Item 4.**Development Application: 51 Buckingham Street, Surry Hills - D/2026/64**

File Number: D/2026/64

Summary**Date of Submission:** 3 February 2026

Figure 10: West elevation

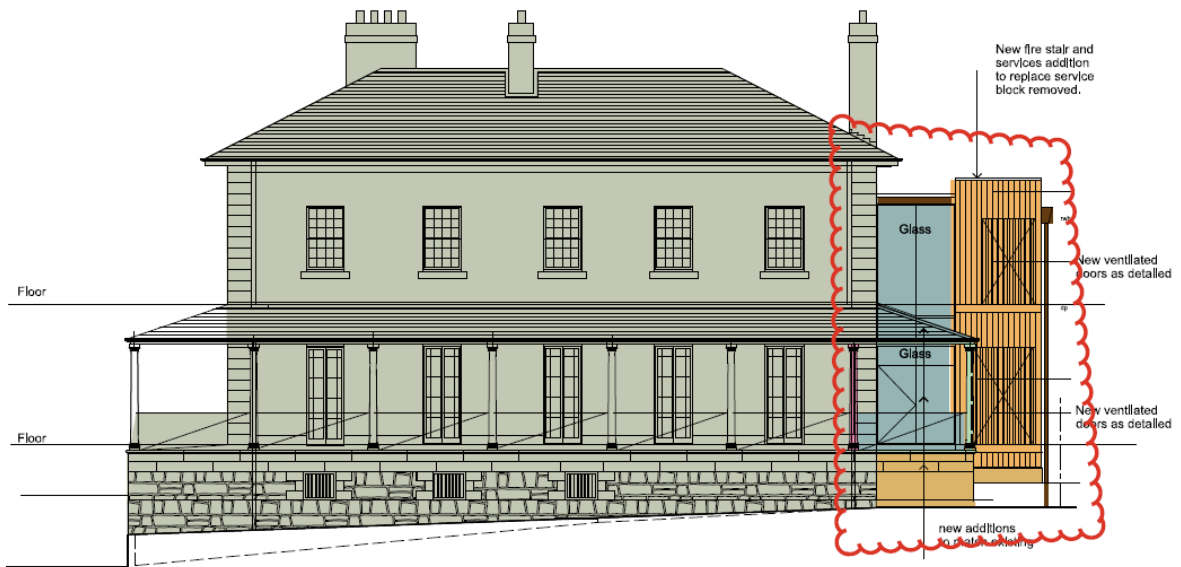
31. Contravention of a development standard pursuant to clause 4.6 of the Sydney LEP
The site is subject to a maximum height of buildings development standard of 6 metres under Clause 4.3 of the Sydney LEP.

32. The proposed development at its highest point has a height of 7.9 metres, which represents a variation of 31.7% from the development standard. It is noted the highest point of the building as defined under the 'building height' definition of the Sydney LEP is currently 11.4 metres being the heritage-significant roof ridge.

36. For the reasons provided above the variation to the height development standard is supported as the applicant has demonstrated the matters required to be addressed by cl 4.6 of the Sydney LEP.

Figure 17: View analysis by the City of Sydney Model Team from the neighbouring residential balcony of the apartment on the second floor

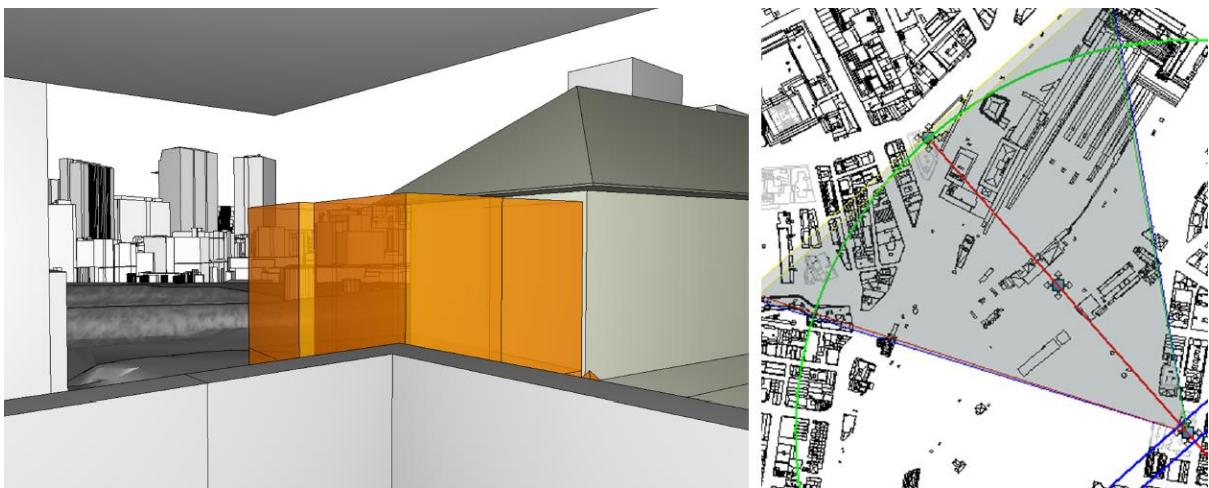
- (a) Views to be affected
 - (i) The view in question is a keyhole view between the Princes Gardens 'Residence A' building and the south-west section of Cleveland House. The view is of the lawn and gardens at Princes Gardens, Chalmers Street, Prince Alfred Park and some city buildings beyond. Refer to Figures 15 to 17 above with view impact imagery which were verified by the City's Model team.

- (ii) The abovementioned views are not water views nor iconic views (e.g. of the Opera House or the Harbour Bridge). It is also a partial district view or outlook, rather than a whole view of the Sydney skyline. Therefore, the view/outlook in question has minimal value compared to water or iconic views or a wider panoramic view of the Sydney skyline being affected.

- (b) From what part of the property the views are obtained
 - (i) The view is at an oblique angle and is across numerous side boundaries, which is more difficult to protect. As noted in the relevant LEC judgement, the expectation to retain side views is often unrealistic and difficult to protect.

- (c) Extent of the impact
 - (i) The view is obtained from a balcony and living room. It is acknowledged the impact on views from living areas and balconies is considered more significant than from bedrooms or service areas.

- (d) Reasonableness of the proposal that is causing the impact
 - (i) The proposal is supported from a heritage perspective with regard to the overall impact on the state heritage item that is in need of repairs and requires maximum retention of heritage fabric. The proposed exceedance from the maximum height of buildings development standard is supported as it is well below the height of the existing roof ridge of the building which is nearly double the height control. Refer above to the Clause 4.6 heading within the discussion section for further height calculations.

46. Given the above, the proposed view impacts are considered reasonable in this instance.
